ADDENDUM ONE

Project: **Sullivan County Immunization**

November 11, 2022

This Addendum is part of the Contract Documents for the above referenced project and modifies the original drawings and/or specifications, dated **10/27/22**, as noted below. The bidder shall acknowledge receipt of this Addendum in the place provided in the Bid Form. The published bid date and time shall remain the same.

IMMUNIZATION PLAN
1/8" = 1'-0"

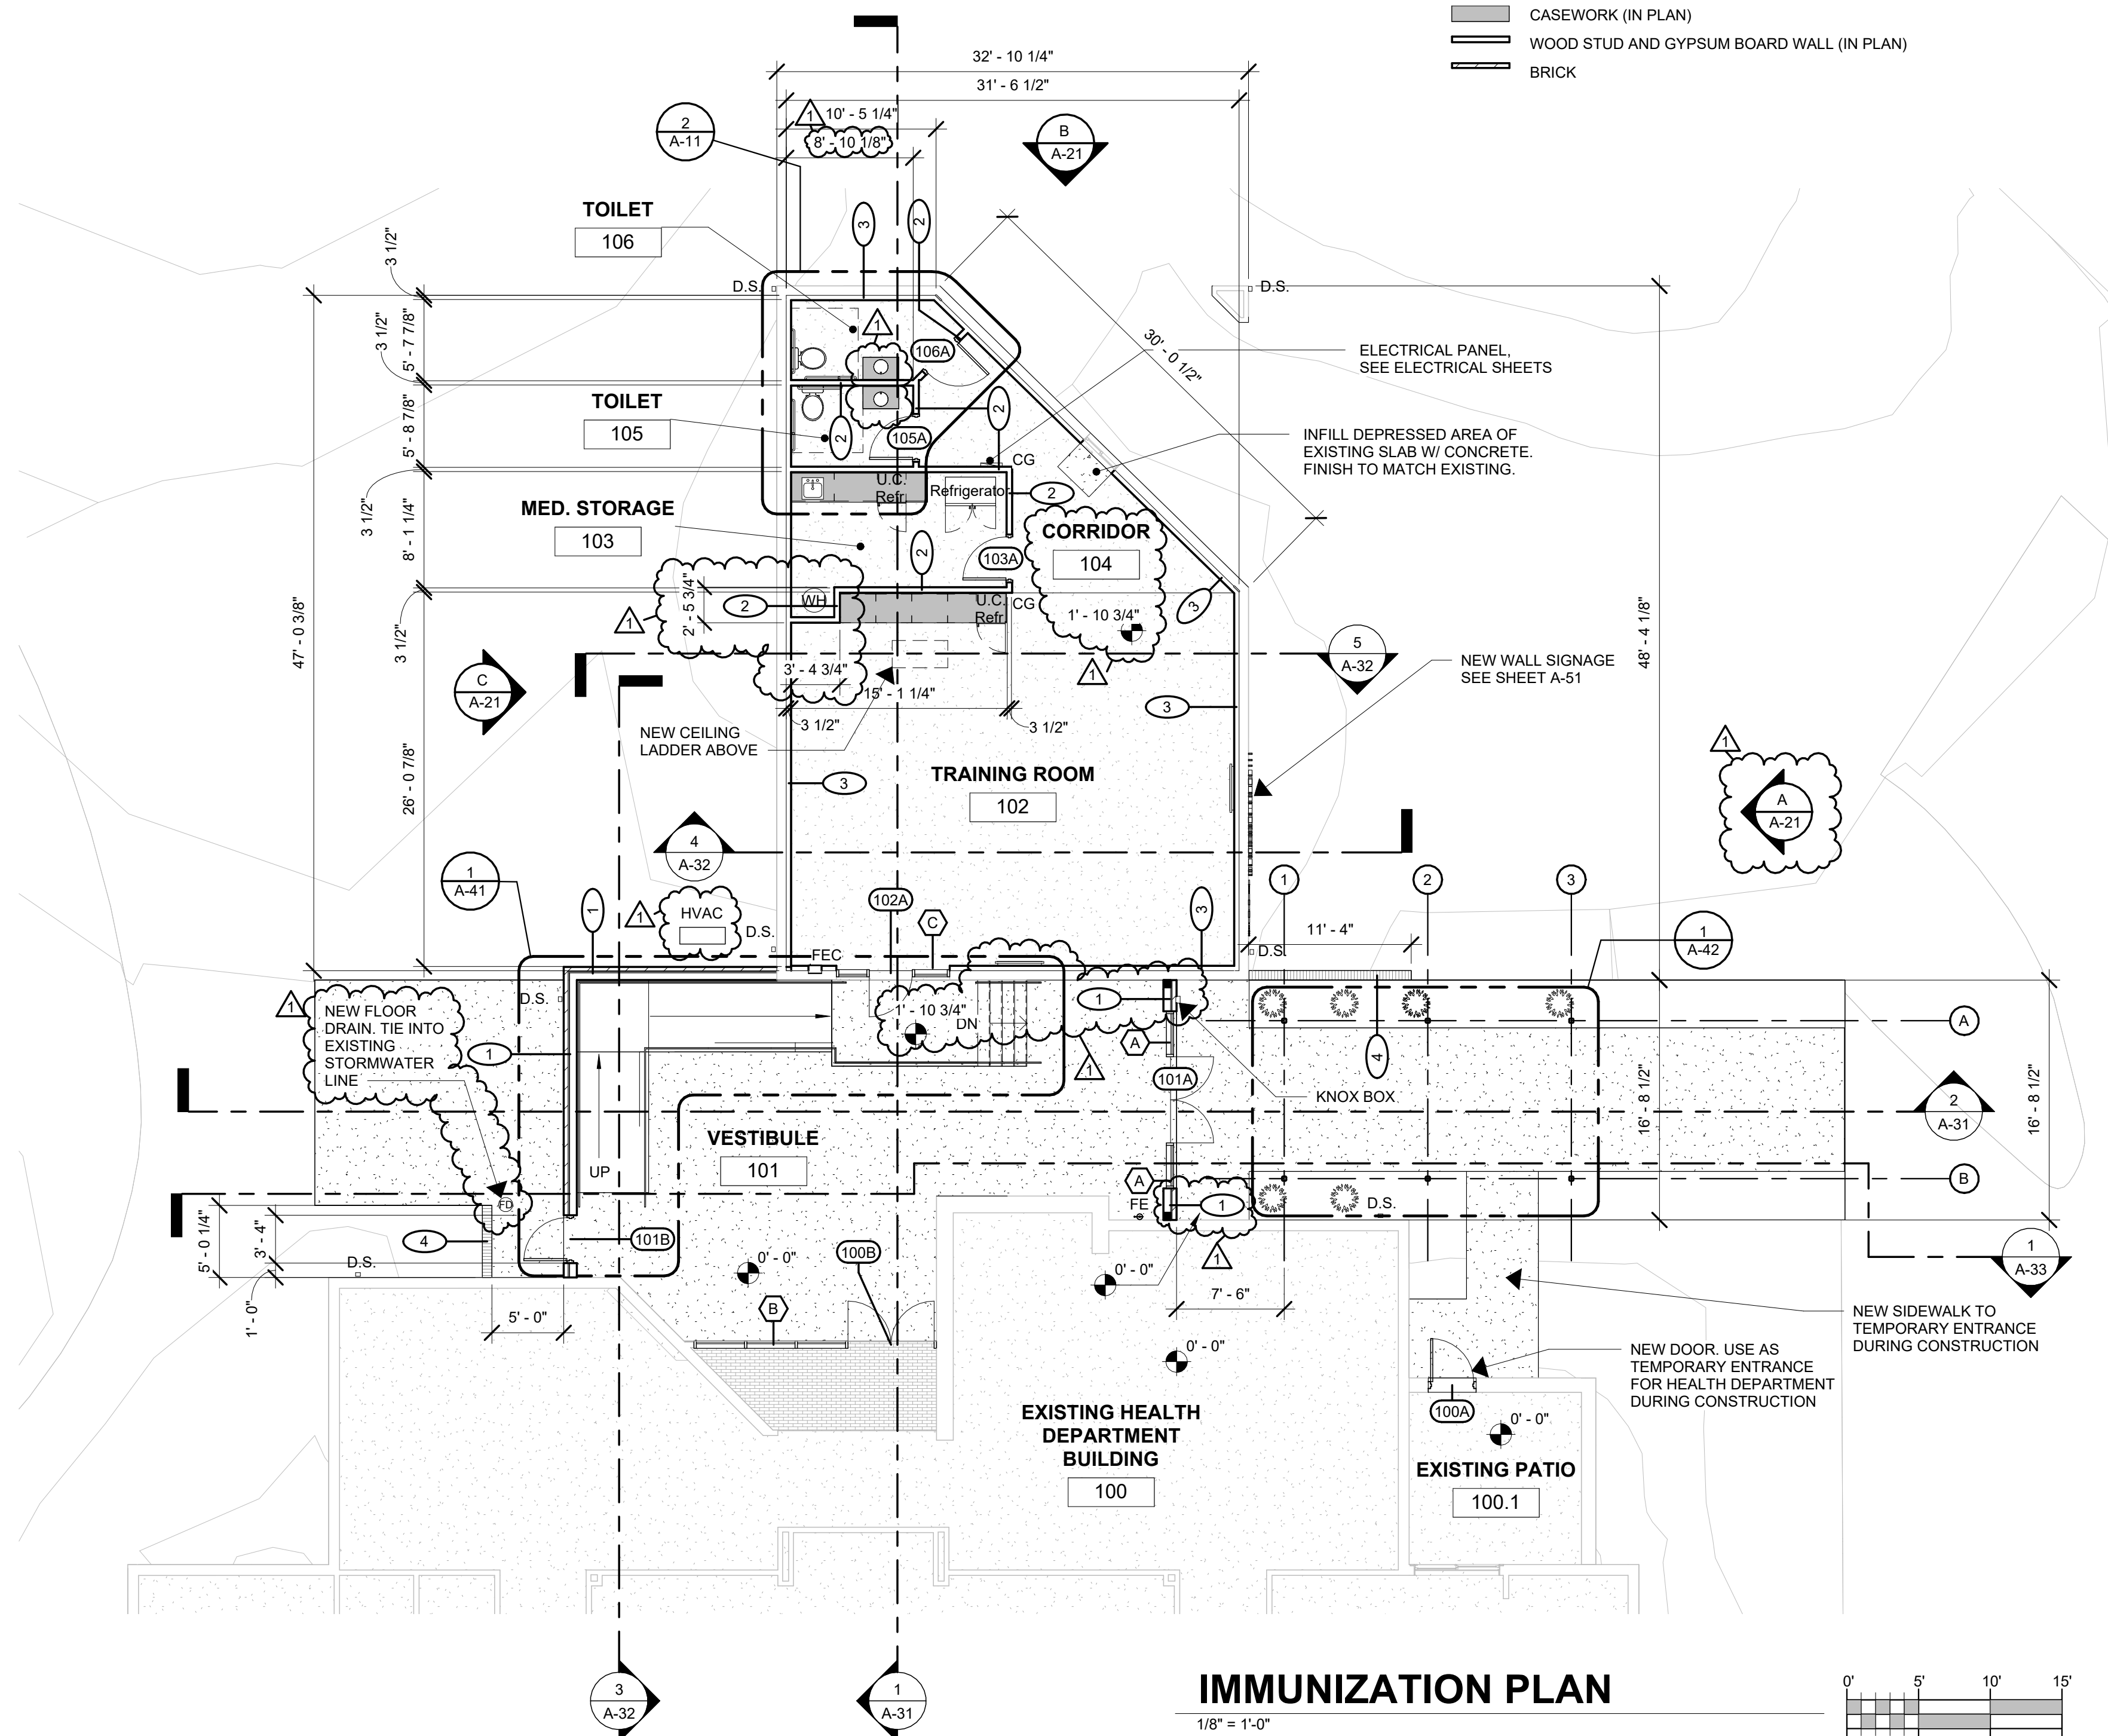
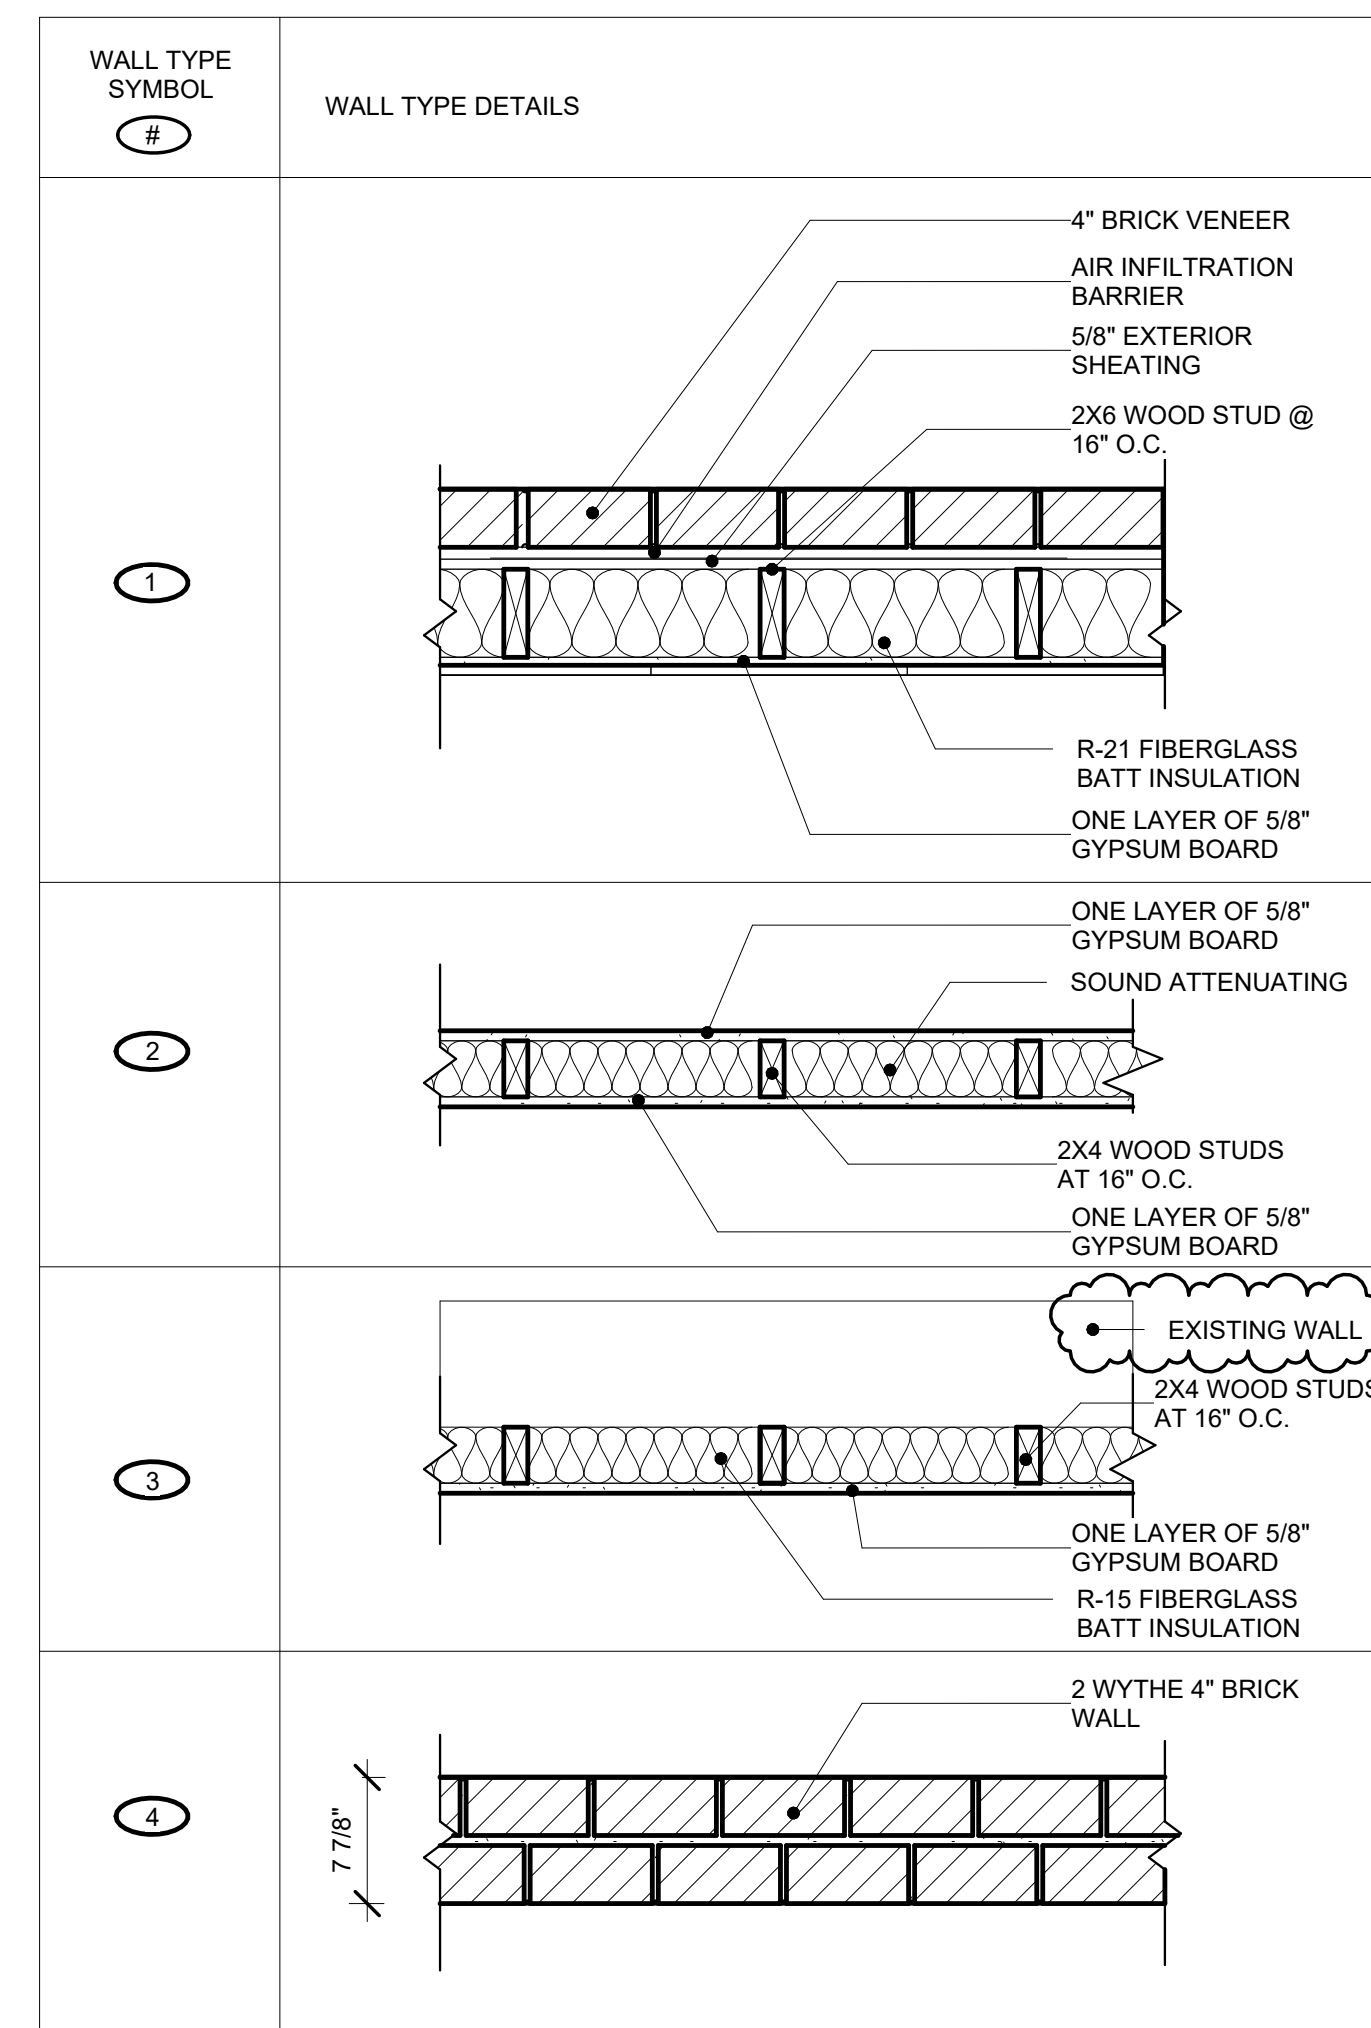
9. **Sheet A-01 Demolition Plan – Base Bid** – remove key note 1, add key note 20.
10. **Sheet A-11 Floor Plan – Base Bid** – change toilet accessories schedule.
